## **Addendum #02 for RFB #911800-02**

Project Name: IVH-Mechanical & Electrical Distribution System Replacement

Addendum #2:

Iowa Veterans Home  
Power Plant Upgrades – DAS #9118.00  
Addendum #2

PANEL BP2 (ALTERNATE #4 ONLY)

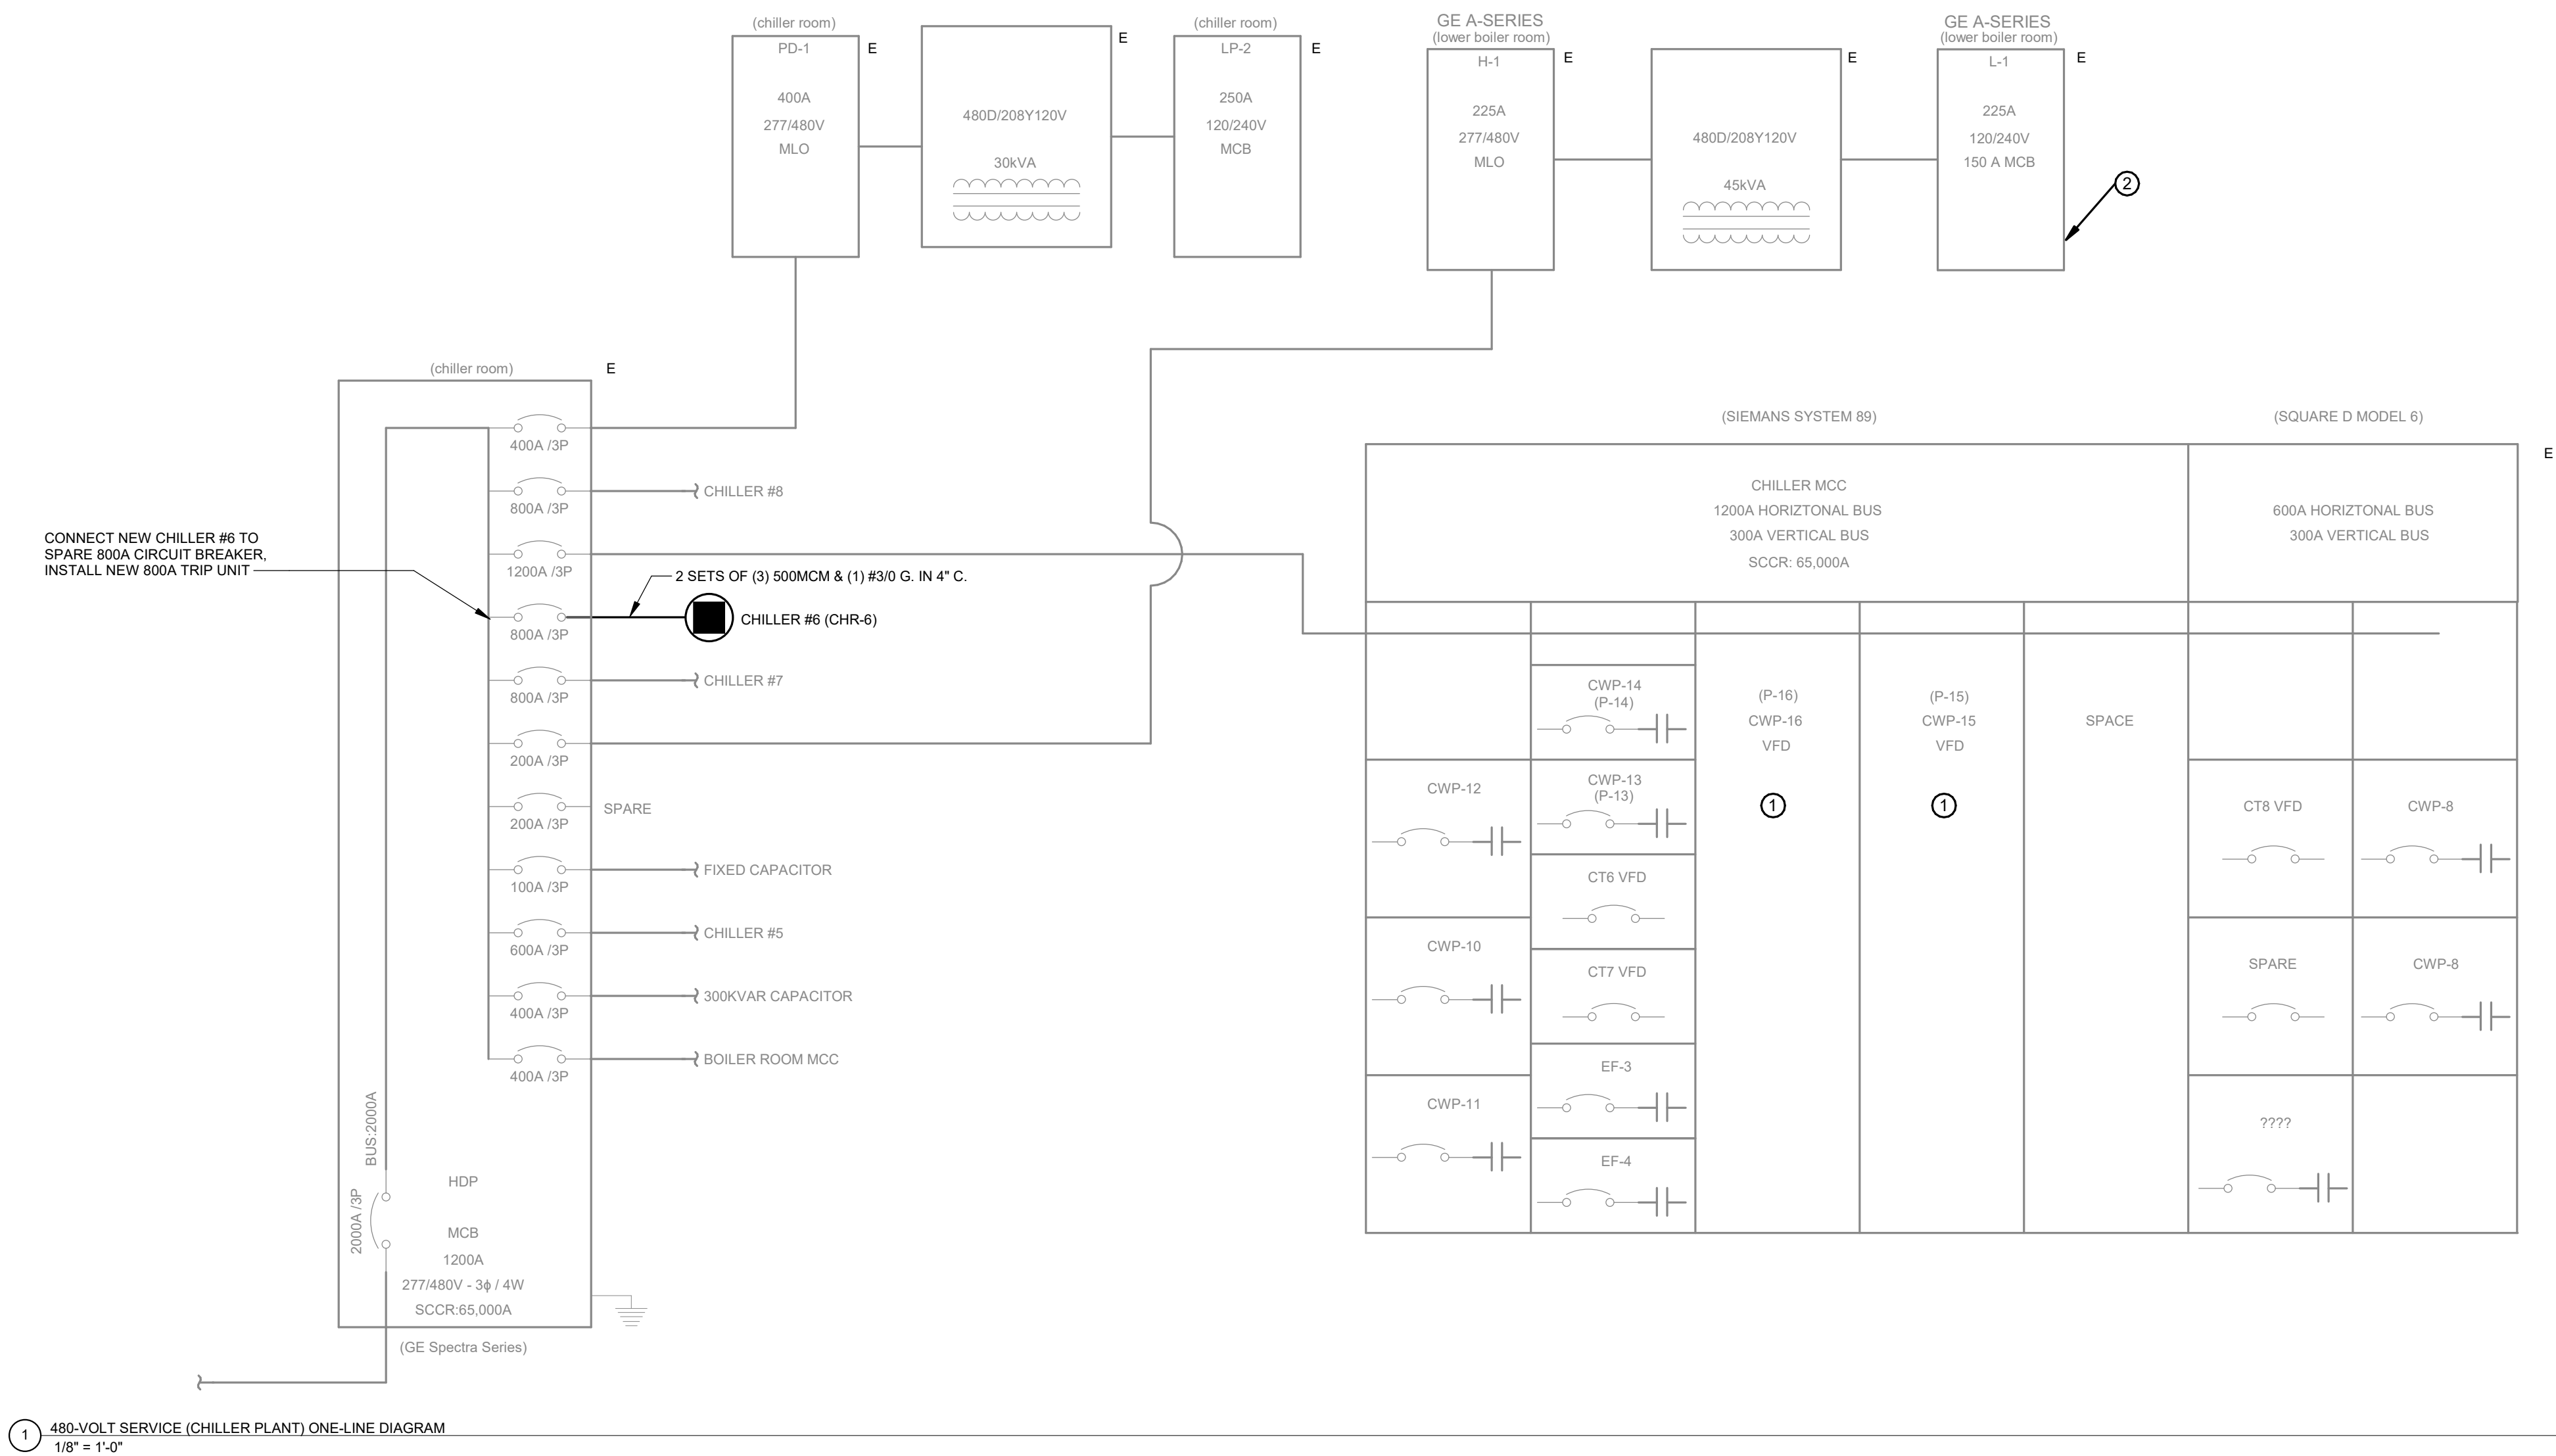
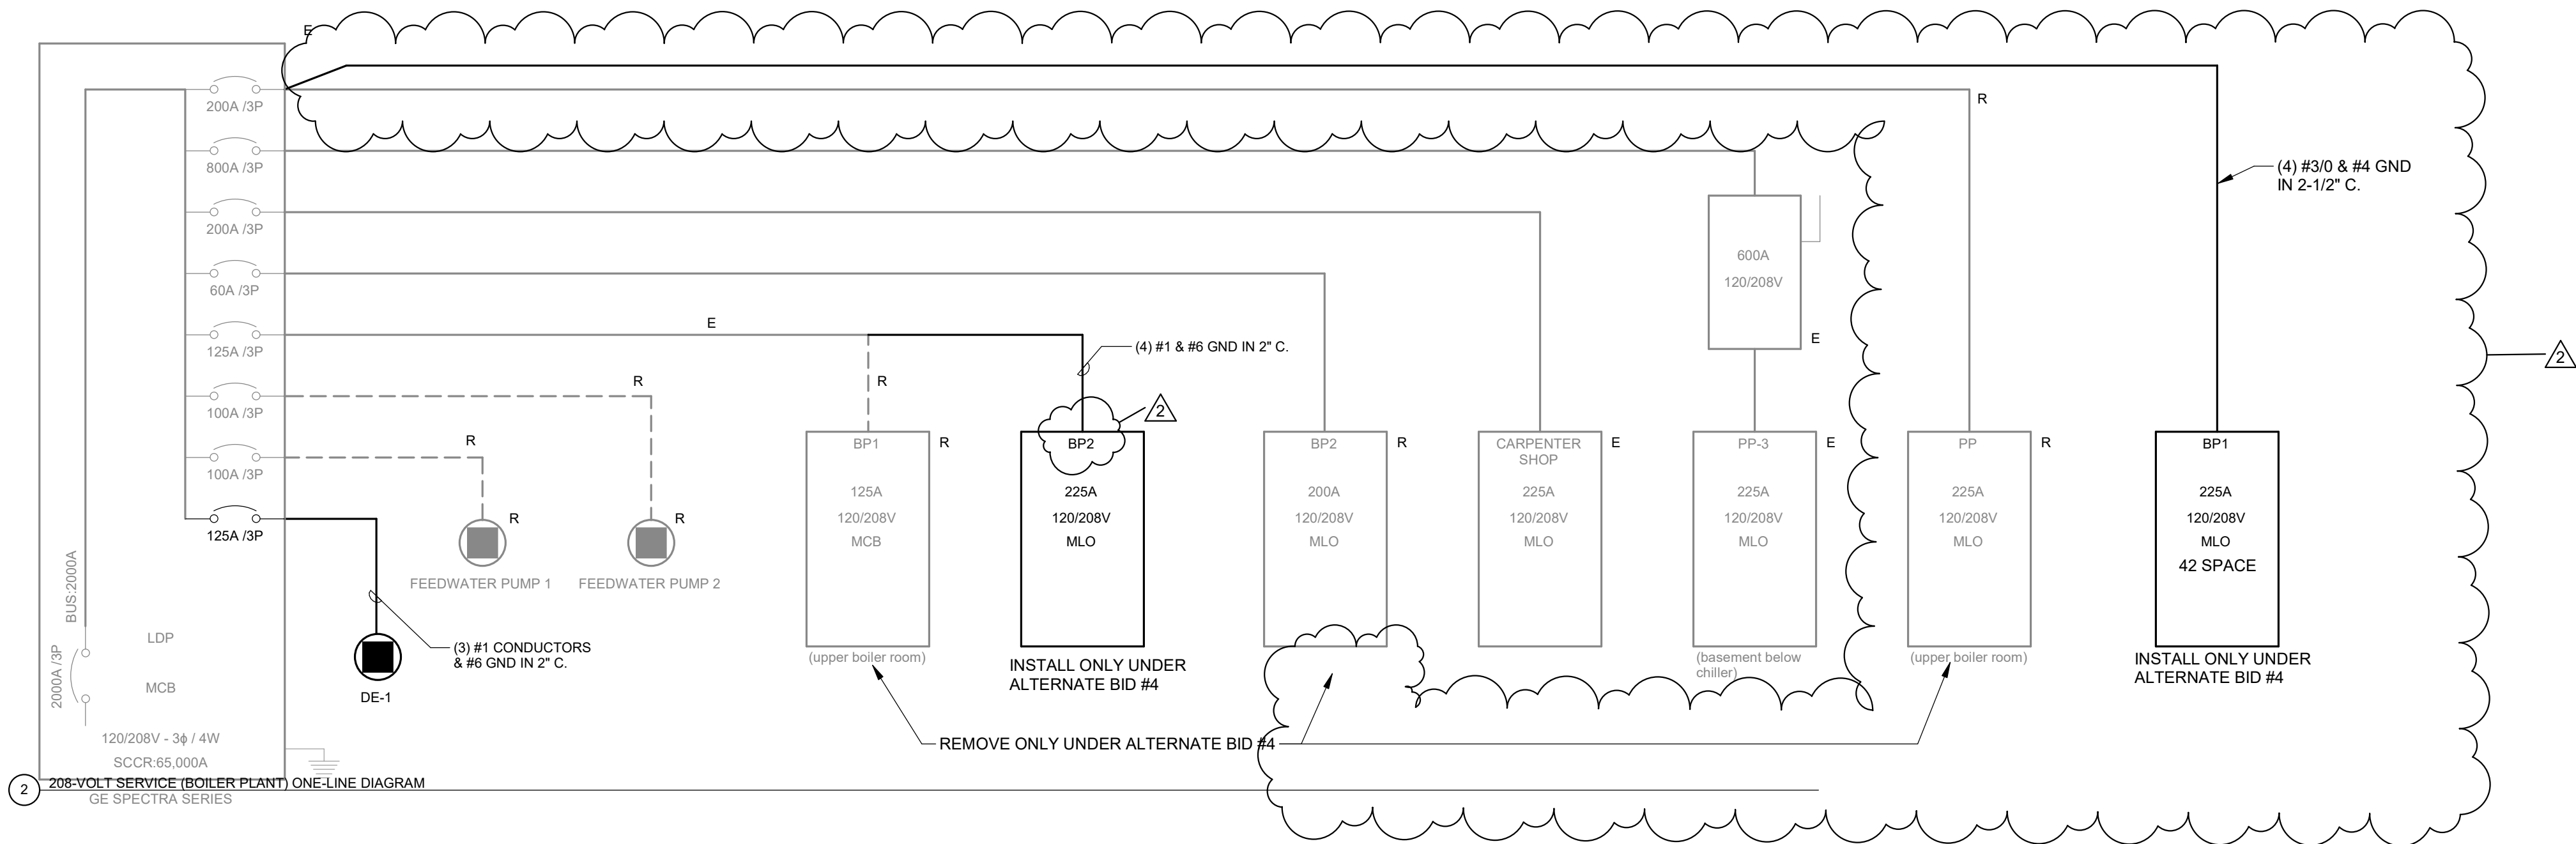
2. Drawing E101
  - a. Change name of BP2 to PP.
3. Drawing E200
  - a. Refer to revisions to Panel BP2 and Panel PP as indicated on attached sketch E1-3.
  - b. Refer to panel schedule for panel BP2 on sketch E1-4.
